## Certificate of Appropriateness Case Report

*Filing Date:* June 5, 2014  
*Case No.:* **2012.1410A**  
*Project Address:* **77-85 FEDERAL STREET**  
*Historic Landmark:* South End Landmark District  
*Zoning:* MUO (Mixed-Use Office) Zoning District  
65-X Height and Bulk District  
*Block/Lot:* 3774/444  
*Applicant:* Adam Franch, Aralon Properties  
482 Bryant Street  
San Francisco, CA 94107  
*Staff Contact* Natalia Kwiatkowska - (415) 575-9185  
natalia.kwiatkowska@sfgov.org  
*Reviewed By* Timothy Frye – (415) 575-6822  
tim.frye@sfgov.org

**RE:** **Meeting Notes - Review and Comment at the June 15, 2016  
ARC-HPC Hearing for 77-85 Federal Street  
Case No. 2012.1410A**

FEDERAL &  
DE BOOM  
ELEVATIONS

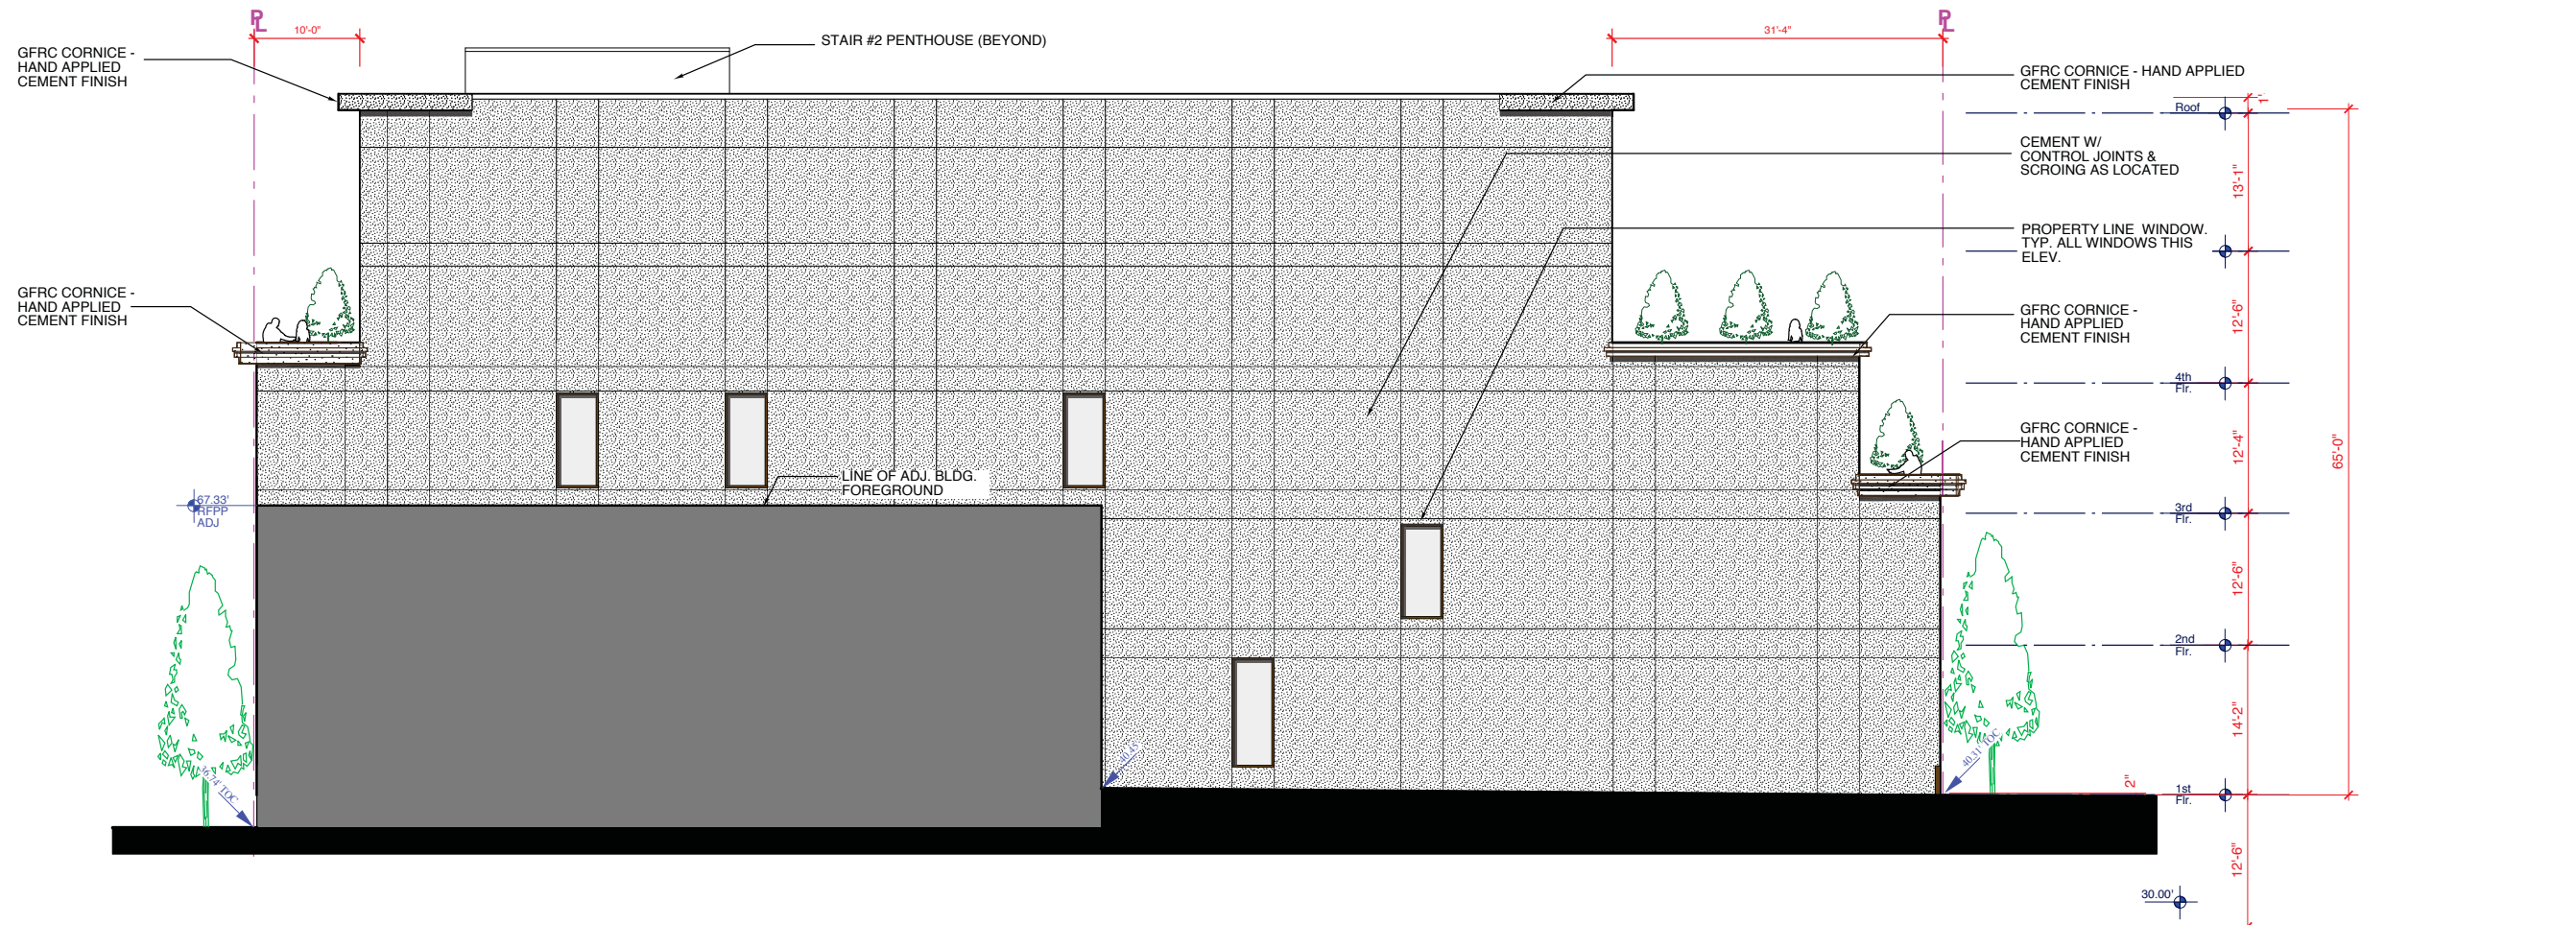
ARC finds that additional articulation is warranted in this location, since a roofline termination is commonly found along the street facade. The Project Sponsor will need to redesign this façade to add a roofline element or cap.

On June 7, 2016, the Architectural Review Committee (ARC) of the Historic Preservation Commission reviewed the proposed project, and provided their recommendations in a letter dated June 15, 2016 (See Attached). The Project Sponsor responded to the comments from the ARC, and revised their design by: replacing the proposed brick cladding with hard-troweled fine diamond cement finish and incorporating the primary façade materials along the entire length of the visible side facades; replacing the previously proposed corten steel pilaster base with an ogee detailed cement base; and refining the cornice on the primary and setback facades facing Federal and De Boom Streets.

ENLARGED EXTERIOR  
DETAILS AT WINDOWS

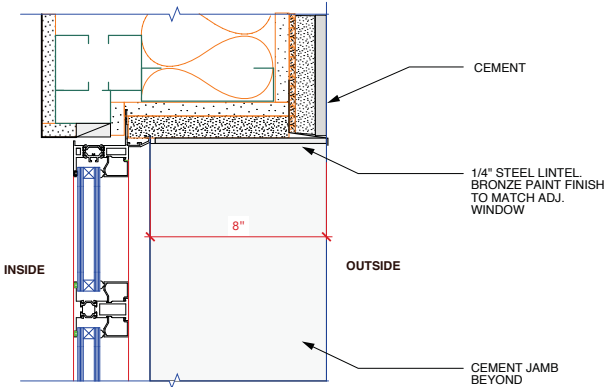
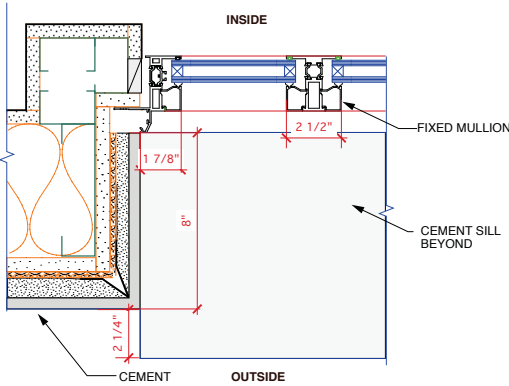
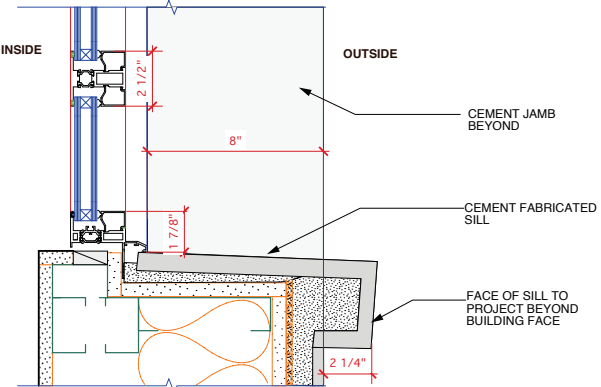
add additional depth on the exterior facade. The Department finds that the proposed fenestration with the projecting sill to be consistent and compatible with the district's fenestration pattern and recess.
